Appln. No. 09/594,875
Amdt. dated May 13, 2004
Reply to Office Action of February 17, 2004

Amendments to the Drawings:

FIG. 6

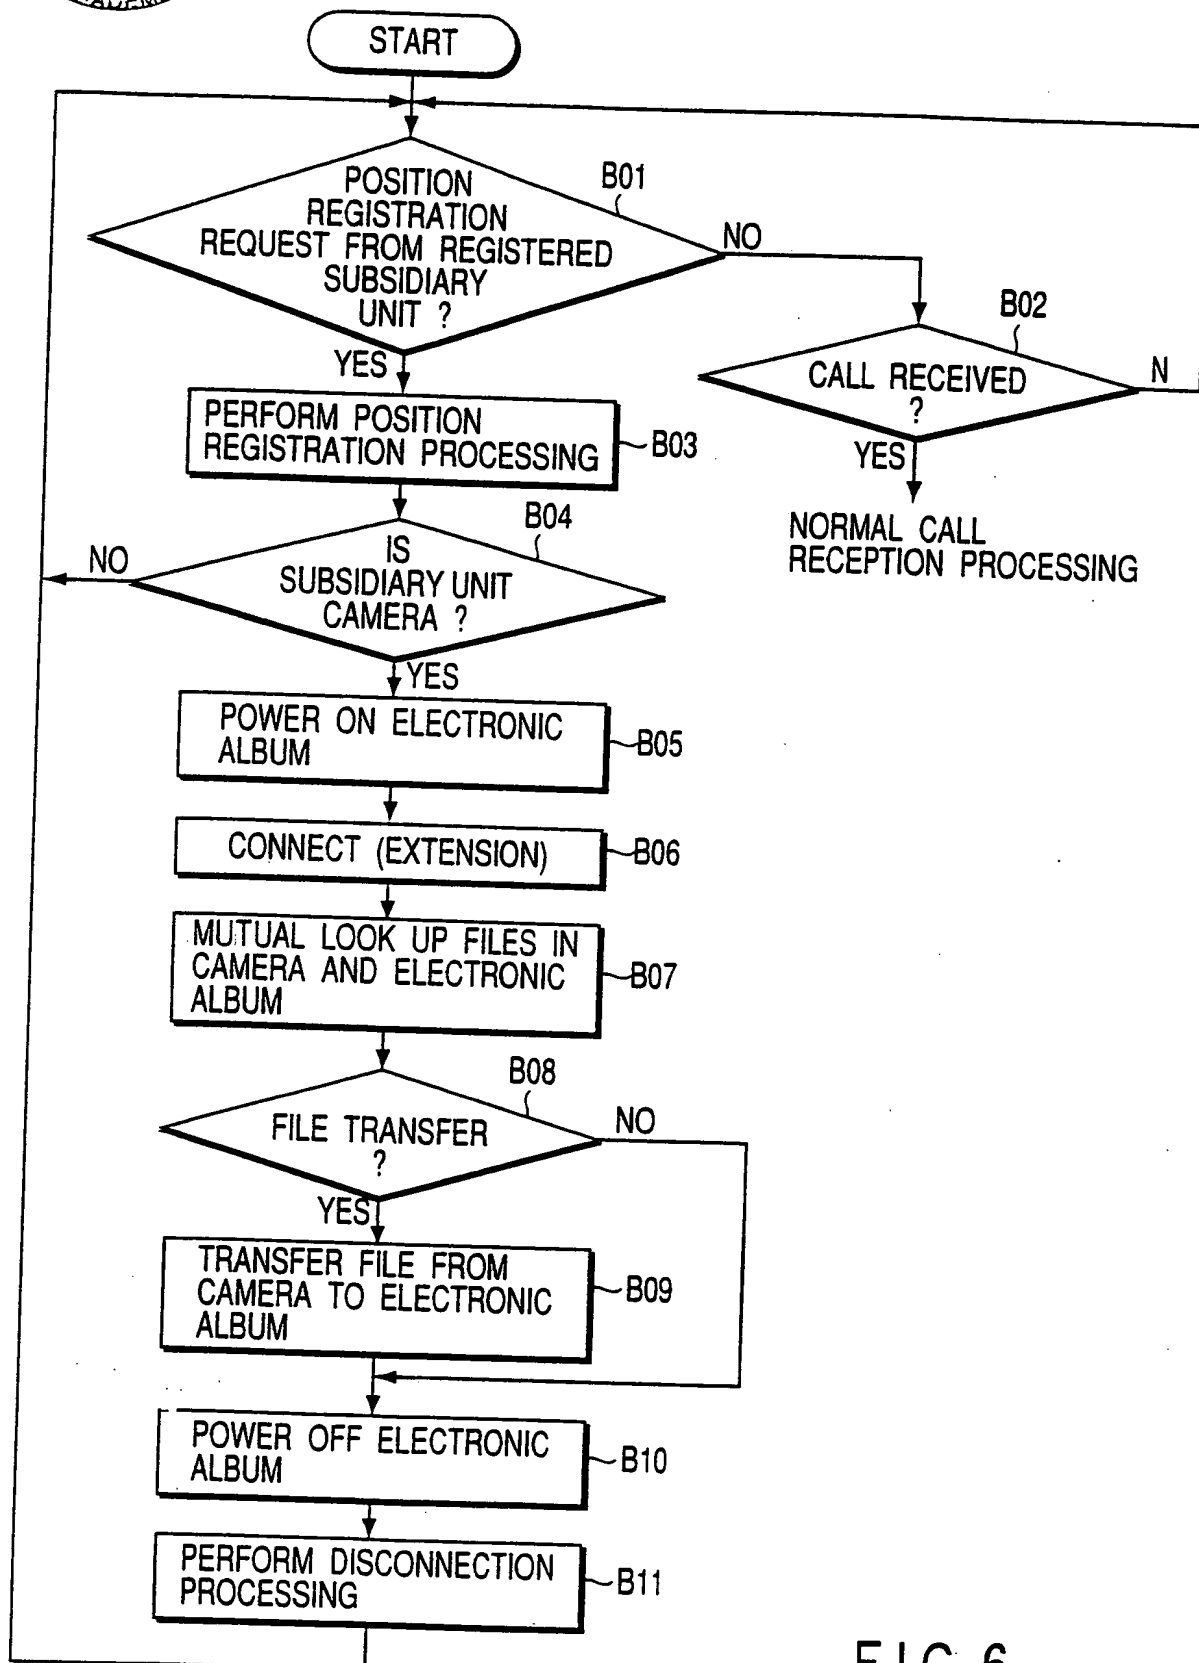
Attached hereto is an annotated sheet showing changes to Fig. 6 and a replacement sheet for Fig. 6. Fig. 6 has been amended to change "munual" in step B07 to -- mutual --. No new matter is added and this amendment is supported by the specification as originally filed.
